UNITED STATES PATENT AND TRADEMARK OFFICE

Office Action Summary

10/511,408

DETAILED ACTION

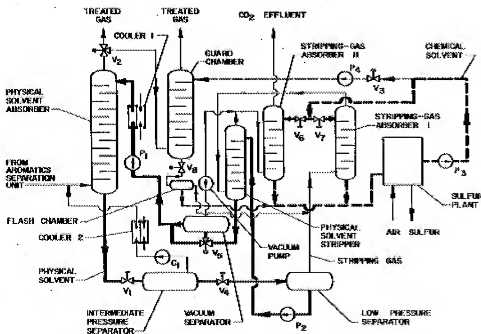
Miller et al (US04080424) disclose process for acid gas removal from gaseous mixture (Title) as shown in the following:

Intermediate pressure separator and low pressure separator which is coupled to the physical solvent stripper through stripping gas absorber 1 and provides stripping gas as illustrated in the Figure above. The intermediate pressure separator liquid output containing the physically absorbed CO₂ and H₂S is then passed through valve V₄ to a low pressure separator reducing the pressure to approximately atmospheric to produce stripping gas for use in stripping gas absorber 1. **The low pressure separator vapor output contains nearly all of the CO₂ and most of the H₂S physically absorbed by the physical solvent.** Stripping gas absorber 1 removes H₂S from the CO₂ stripping gas by use of an H₂S selective chemical solvent (Col. 5, line 17-27).

As to step of separating in at least one of a high-pressure flash vessel and a medium pressure flash vessel a substantially hydrogen sulfide-free stripping gas from a physical solvent in a method of producing an ultra-clean physical solvent in **independent claim 12**, Miller et al (US04080424) disclose intermediate pressure separator and low pressure separator to produce liquid output and stripping gas containing nearly all of the CO₂ and most of the H₂S physically absorbed by the physical solvent (Col. 5, line 6-27).

As to step of feeding the substantially hydrogen sulfide free stripping gas into a vacuum stripper hydrogen sulfide to thereby strip hydrogen sulfide from a carbon dioxide-depleted lean hydrogen sulfide-containing physical solvent in the vacuum stripper to so form the ultra-lean physical solvent in a method of producing an ultra-clean physical solvent in **independent claim 12**, Miller et al (US04080424) disclose the gaseous output from the stripping gas absorber 1, mainly CO₂ free of H₂S, is used as a stripping gas to remove H₂S from low pressure separator liquid output which is passed in countercurrent flow relationship in the physical solvent stripper (Col. 5, line 28-32).

As to step of feeding the ultra-clean physical solvent to an absorber in **claim 13**, Miller et al (US04080424) disclose gas input from aromatic separation unit to the physical solvent absorber as shown in Figure above. A portion of the liquid output of the physical solvent stripper controlled by valve V5 may be passed through the vacuum separator, thereby further reducing the CO₂ content of the physical solvent stream to about 1 mole percent – ultra-lean physical solvent (Col. 5, line 32-38).

As to step of operating with an isothermal gradient or with a decreasing top-to-bottom thermal gradient in **claim 13**, Miller et al (US04080424) disclose the physical solvent absorber as shown in Figure above. To minimize the rate of physical solvent circulation, it is desirable to introduce the regenerated physical solvent into the top of the physical solvent absorber at as low a temperature as practical (Col. 4, line 38-41). When the gas is the product of coal gasification the pressure in the physical solvent absorber **may be** at about 800 to 1200 psia and the temperature of the gaseous stream input to the physical solvent absorber at about 60 to 120° F. Any configuration of gas-liquid contact chamber is suitable, desirably one exhibiting a low pressure drop and high volume flow through such chamber (Col. 3, line 54-55). Miller et al **do not teach** the absorber to be configured to operate with an isothermal gradient or with a decreasing top-to-bottom thermal gradient as claimed.
